Plat Waiver from the Cul-de-Sac Length Limitation in UDC 8.2.1.G

Kenley Estates (Final Plat)

Planning Commission Meeting

August 8, 2018

Dimensioned Lay out

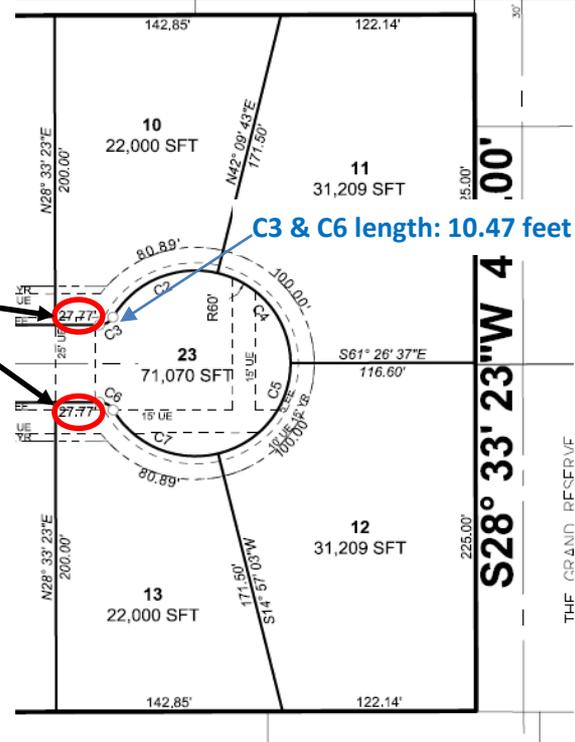
- 1,143 feet > 1,000 feet limit.
However, mitigating factors:
- Lots 1 & 22 are non-buildable lots, for detention ponds; *not traffic generators*
- Width of Lots 1 & 22:
 $98.77' + \frac{1}{2} \text{ Curve Length } 11.78' = 110.55'$
- Subtract the non-traffic generating lot width from the cul-de-sac length:
 $1,143 \text{ feet} - 110 \text{ feet} = \mathbf{1,033 \text{ feet}}$
- **33 foot excess**
